STRATFORD EXTENSION PROJECT

INDEPENDENT REVIEW OF GROUNDWATER ASSESSMENT

DUNDON CONSULTING PTY LTD

13-0262-R01

Figure 3: Predicted Water Table Drawdowns at the End of the Project – Stratford Extension Only and Cumulative Drawdowns.

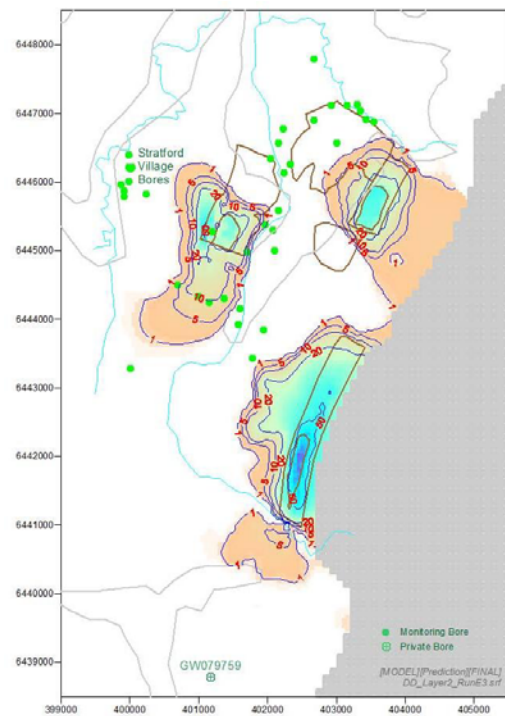
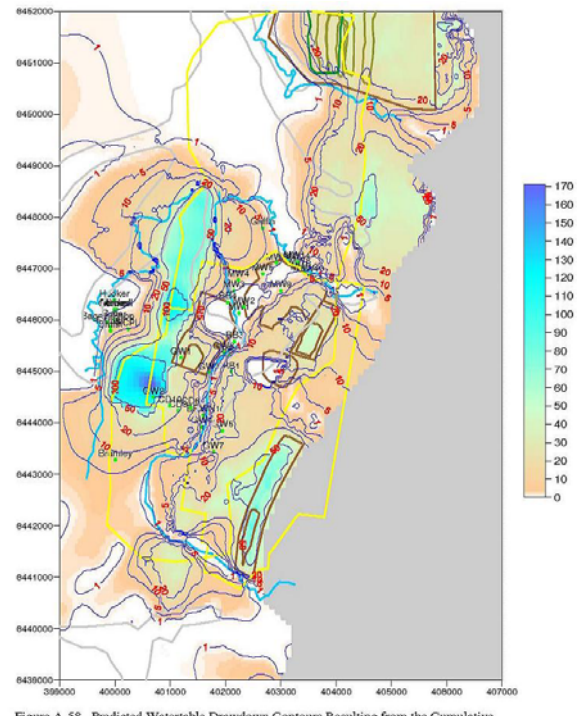
Predicted drawdowns in the water table at the end of mining due to the Stratford Extension Project only are shown on the left in **Figure 3** below, and indicate that the extent of drawdowns exceeding 1m is quite localised, and do not include either Stratford Village or the only other private licensed bore (GW079759, located to the south).

The cumulative impact of the Stratford Extension, together with the AGL CSG project and the Rocky Hill Coal Project, at the end of the Stratford project in 2024, are shown on the right in **Figure 3** below. The region with water table drawdowns exceeding 1m is much more extensive. However, again the impact on existing users in Stratford Village and the southern registered bore is less than 1 m drawdown.

In both cases illustrated below, the 1 m drawdown effect does not extend as far as the nearest mapped 'biophysical strategic agricultural land' along the Avon River, which is more than 2000m away from the proposed mining areas in the proposal.

In **Paragraph 5** the Committee questions the veracity of the groundwater modelling, saying that in one case a 1.5 km drawdown is predicted. I have been unable to find reference to this magnitude of pressure reduction. Figure A-58 (Heritage, 2012) shows maximum cumulative water table drawdowns up to approximately 150m, but not as great as 1500m. The drawdowns due to Stratford Extension Project alone are much smaller, with drawdowns of more than 10m extending only a few hundred metres from the open cuts. Subject to the comments above, I am confident that the modelling has been carried out appropriately, and I am confident in the results.

Figure 4: Predicted Combined Groundwater Inflows to All Open Cuts

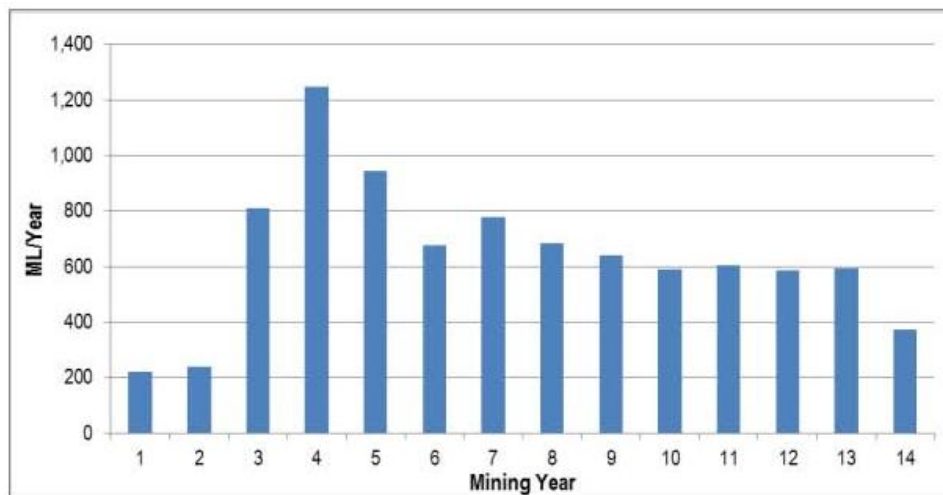
Total groundwater inflows to all mine pits are predicted to range up to 1.25 ML/a. The peak inflow rate is predicted to occur in Year 4, as indicated in **Figure 4** below. From Year 6, inflows stabilize around 0.6 ML/a.

AGE indicate that the seepage rates in **Figure 4** do not allow for evaporation losses or removal of water in the coal and waste rock extracted from the pits. Accordingly, the actual accumulation of groundwater in the pits could be up to 25% less than the rates predicted by the modelling.

Figure 5: Predicted Drawdowns in Water Table (Model Layer 1) at End of Mining (Year 13) – AGL Only and Rocky Hill Only

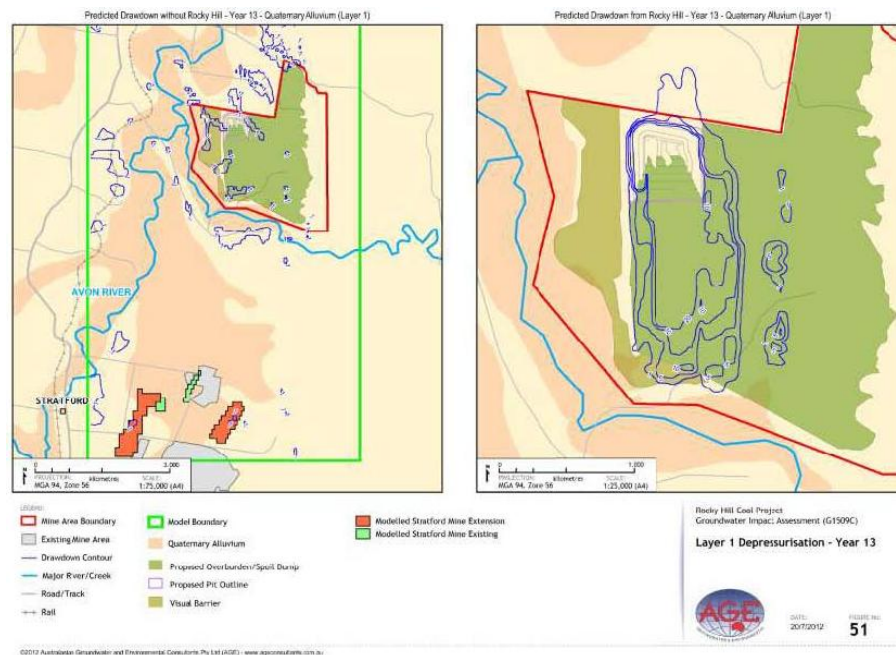
Predicted drawdowns in the water table at the end of mining due to the Rocky Hill Coal Project only are shown on the right in **Figure 5** below, and indicate that the extent of drawdowns exceeding 1m is localised virtually to within the pit area, extending a maximum of 500m from the northern extent of the main pit. There is predicted to be a small encroachment into the Waukivory Creek alluvium at the southern end of the mine areas.

The predicted drawdowns in Layer 1 (see **Figure 5** above) do show some drawdown in the alluvium, in three areas:

Cumulative drawdown impacts have not been presented for the water table. Rather, AGE have presented the predicted water table drawdown due to the AGL project, without the Rocky Hill project, as depicted below on **Figure 5** above in **Section 5.4.2**. The report text infers that both AGL and Stratford projects are included in the left pane of **Figure 5**, however, there are no drawdown contours around the Stratford Mine near the southern boundary of the AGE model, and the Heritage report did predict water table drawdowns in that area at Year 2024, which presumably would equate to Year 10 or Year 11 of the Rocky Hill project. Hence, it is concluded that **Figure 5** does not include any impact from Stratford.

Figure 6: Predicted Cumulative Drawdowns AGL Project and Stratford Extension Project (Excluding Rocky Hill Project) – Model Layer 5 – Year 7 and Year 13

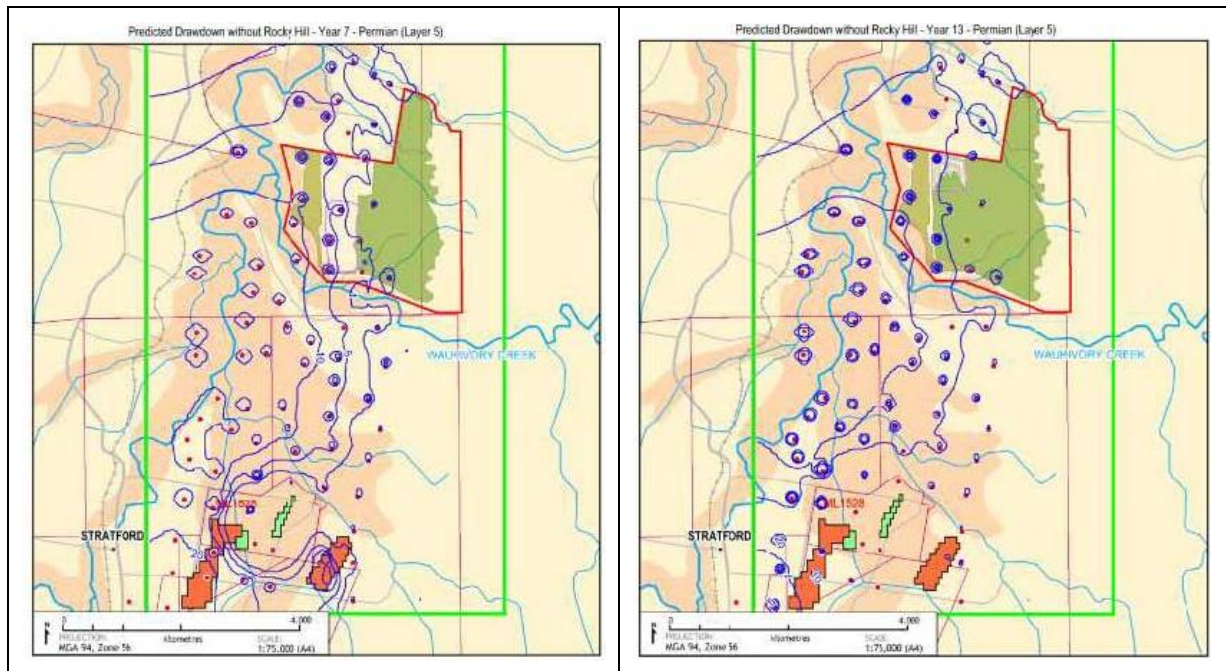
Cumulative drawdowns in the coal measures are more significant, as illustrated by the predicted drawdowns in Model Layer 5 at Years 7 and Year 13 on **Figure 6** below.

There are several zones of predicted water table drawdown exceeding 1 m that superimpose with the mining impacts, but also occur broadly outside the zone of Rocky Hill impact.

The AGL project has a much more severe and more widespread effect on depressurisation of the underlying coal measures, with greater than 100 m depressurisation at each wellhead and greater than 10 m depressurisation over the wellfield area which overlaps with the Rocky Hill Project. The depressurisation effects of the AGL project are predicted by the AGE model to not have a significant impact on the water table, hence the limited impacts displayed in **Figure 6**.

It is not clear how AGE included the Stratford mining operation in their model. Being on the model boundary, it is likely that model edge effects would influence the predicted drawdowns. It appears that AGE reviewed the predicted impacts described by Heritage in the Stratford groundwater assessment report, and included the predicted drawdowns from the Heritage report at the appropriate years. Note that by Year 13 of the Rocky Hill project, the Stratford Extension project is expected to be completed, so there is no impact shown around the Stratford project for Year 13 above.
